ADDENDUM NO. 03

Northland Corridor Redevelopment Project Phase 4
631 Northland Ave.
Buffalo, NY 14211

Project No. 432607

Project Northland Corridor Redevelopment Phase 4 (BUDC) Addendum No. 3
631 Northland Avenue, Buffalo, NY Contract -
Wendel Project No. 432607 Date 10/22/25

C302

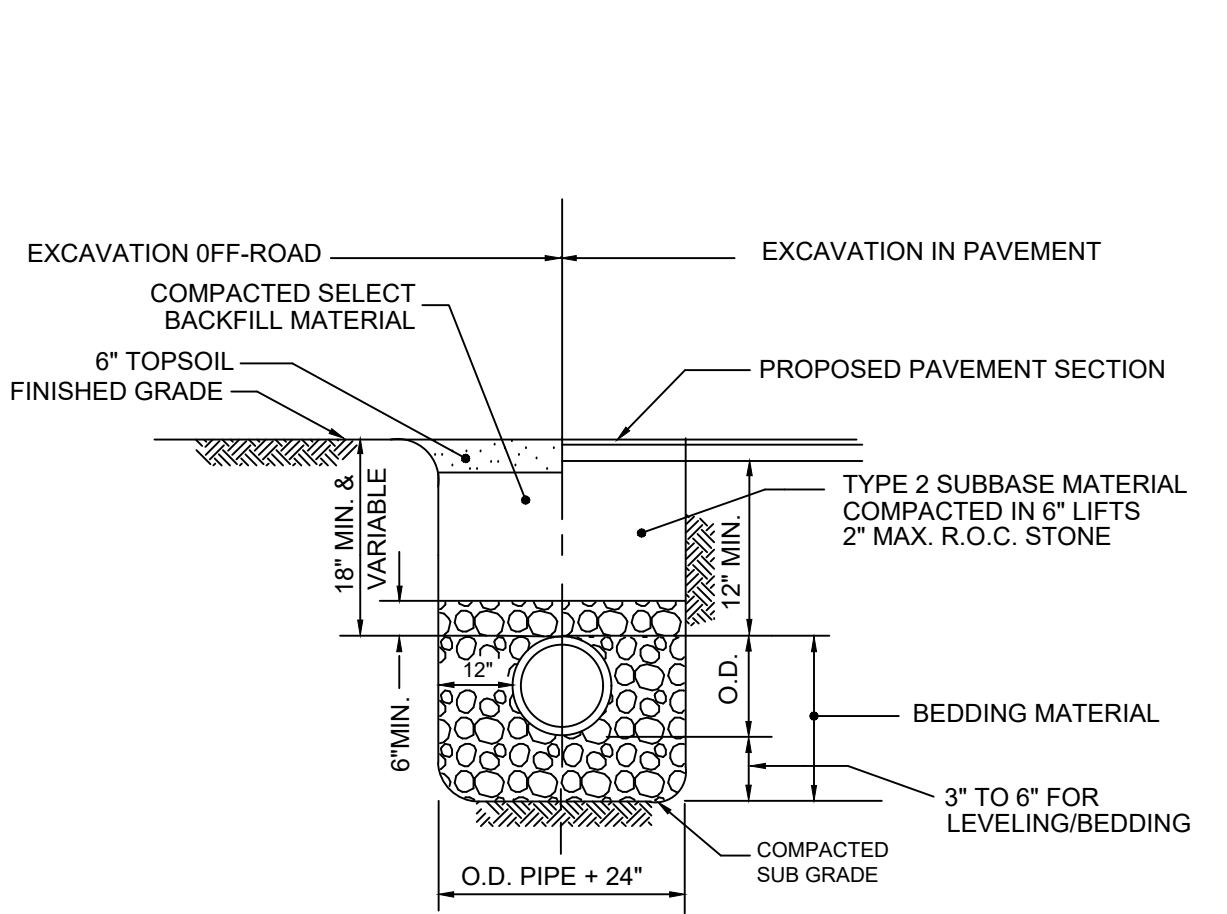
DELETE: Civil drawings C102, C103, C201, C301, C302, C503, C504.

CLARIFICATION: Revisions in the above referenced sheets accommodate environmental requirements and provide clarification to utilities, drainage, and grading.

ADD: Revised civil drawings C102, C103, C201, C301, C302, C503, C504 issued as part of this addendum.

A901

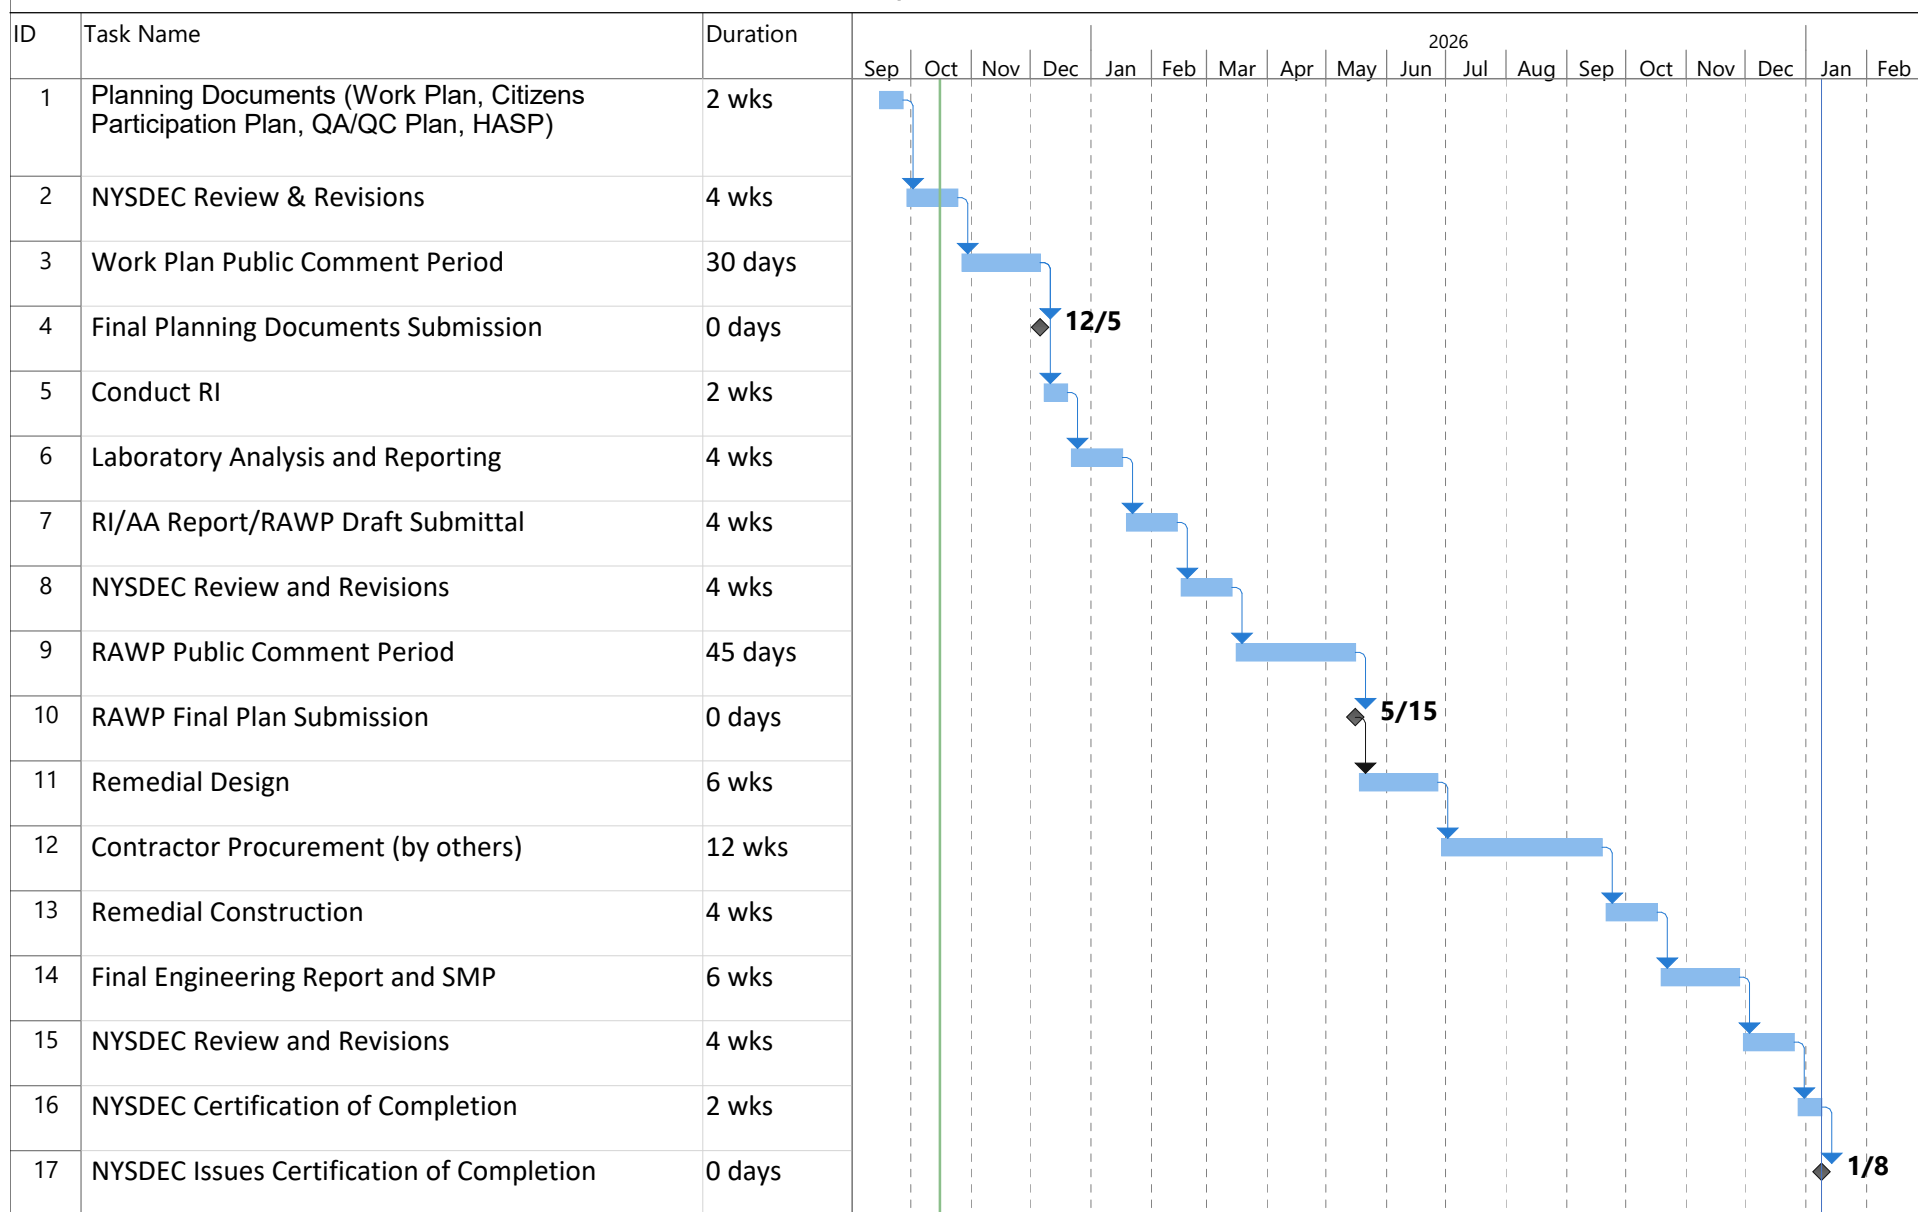
1. Door hardware is in Section 087100 which was inadvertently omitted from the original spec. Refer to specification Section 087100 attached to this addendum.
2. Drawing sheets A301 and A900 were revised and issued under Addendum 02.
3. Please refer to window elevations and coordinate with schedule. Please ask specific questions if contractor(s) are unclear on anything further.
4. Refer to revised drawing A901 removing snap trim from windows. There should be no snap trim.
5. Refer to revised drawing A901. SHPO & NPS final approval on windows are pending the window mockup in process. Contractor and awarded window manufacturer are responsible for verifying in field and confirming details via shop drawings. Design intent is that windows shall receive wood blocking where the head and/or sill have steel angles present.

REPLACE: Drawing sheet A901 with the revised issued in this addendum.
